Re: Addendum 1 to Geotechnical Evaluation
Lowry Avenue Bridge Replacement Project
Interim Connection Retaining Wall
Lowry Avenue between Marshall Street and the West Bank of the Mississippi River
Minneapolis, Minnesota
Bridge No. 27B60
State Aid Project No. 27-753-16

This letter serves as Addendum 1 to our Geotechnical Evaluation Report for this project, dated December 29, 2008. This Addendum addresses design and construction of the proposed retaining wall for support of the eastbound interim connection, along with deep foundation recommendations for the Interim West Abutment.

Addendum 01

Pier 4 - revised - Axial Compression - 16" Diam CIP, CE

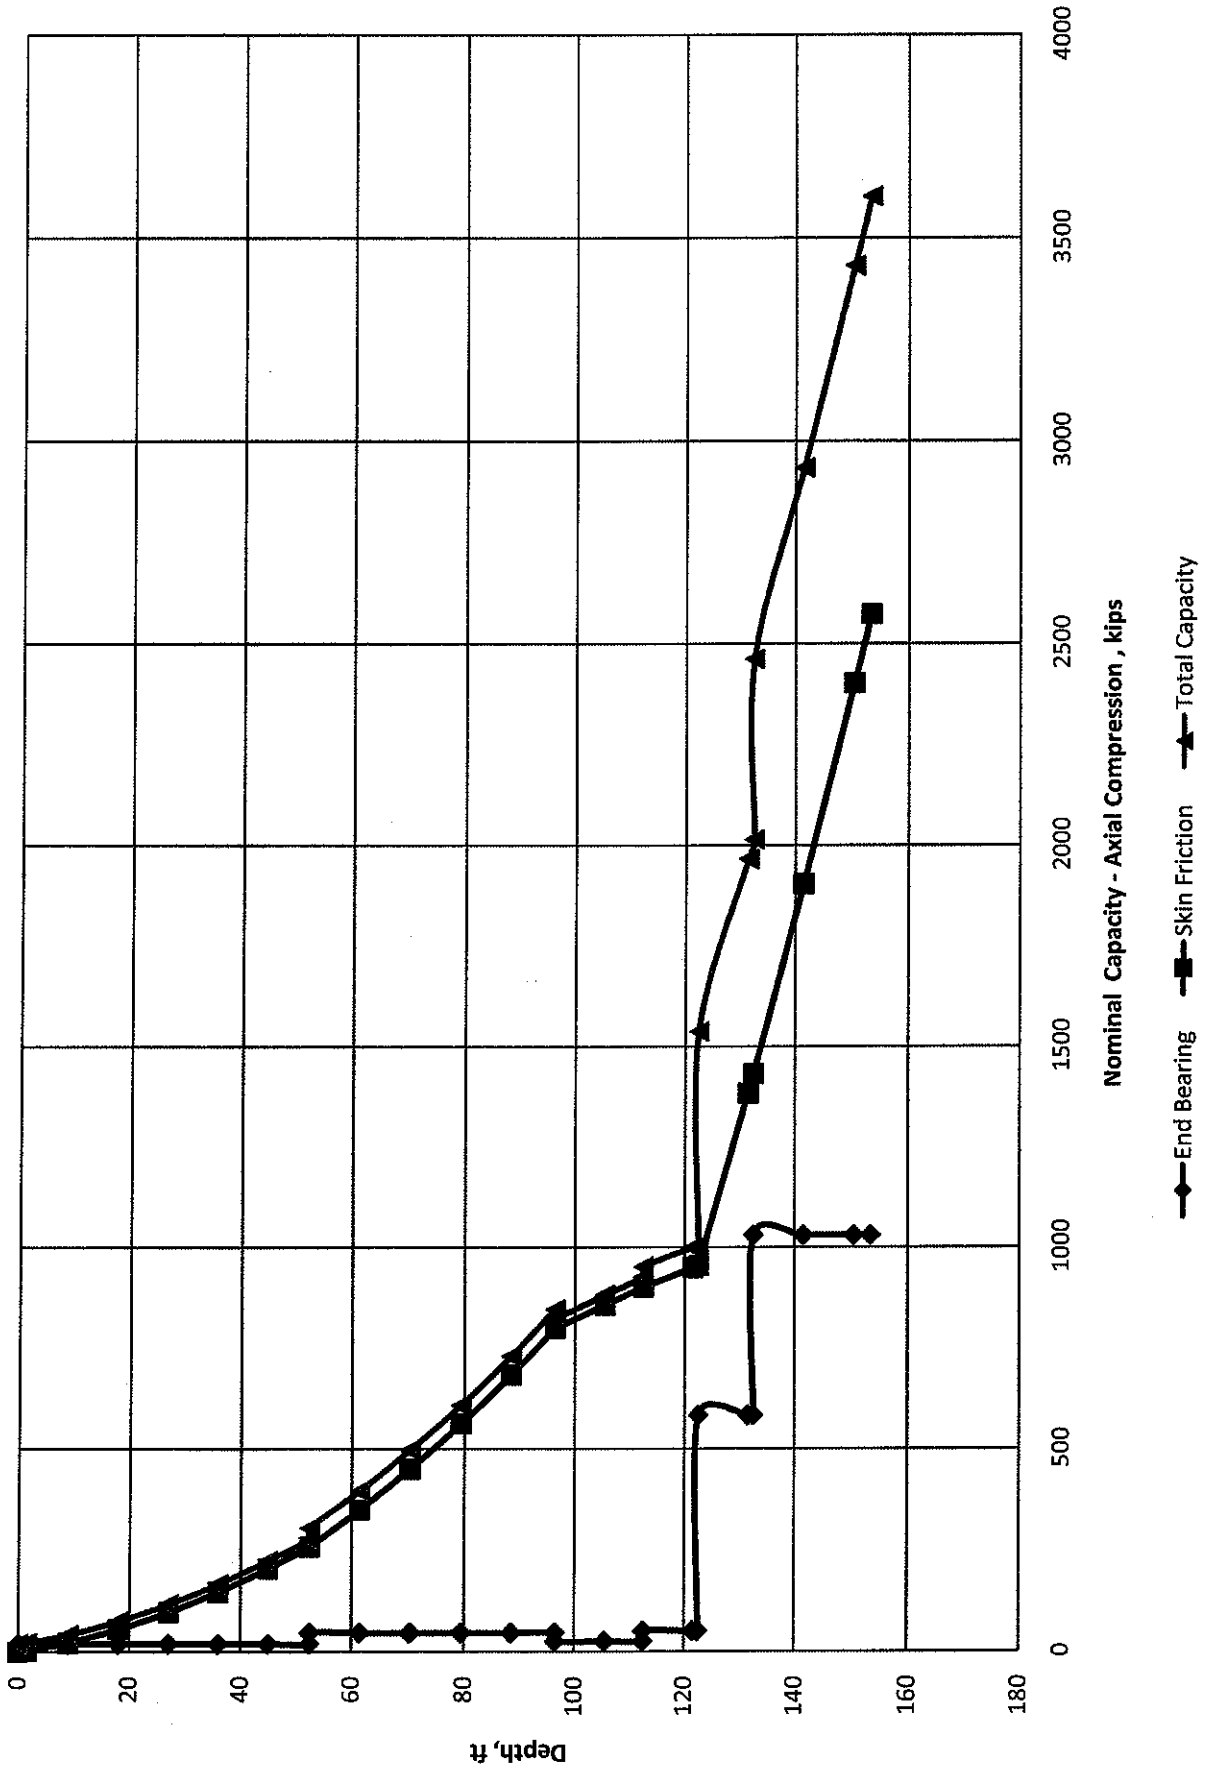
We also understand that the planned bottom-of-pile-cap (BOPC) elevations for Pier 4 and the East Abutment have changed. The current design elevations are about 810 and 798 for Pier 4 and the East Abutment, respectively.

As a result of the changed bottom-of-pile-cap elevation for Pier 4, we have revised the Nominal Compression Capacity versus Pile Length and Nominal Uplift Capacity versus Pile Length graphs for Pier 4.
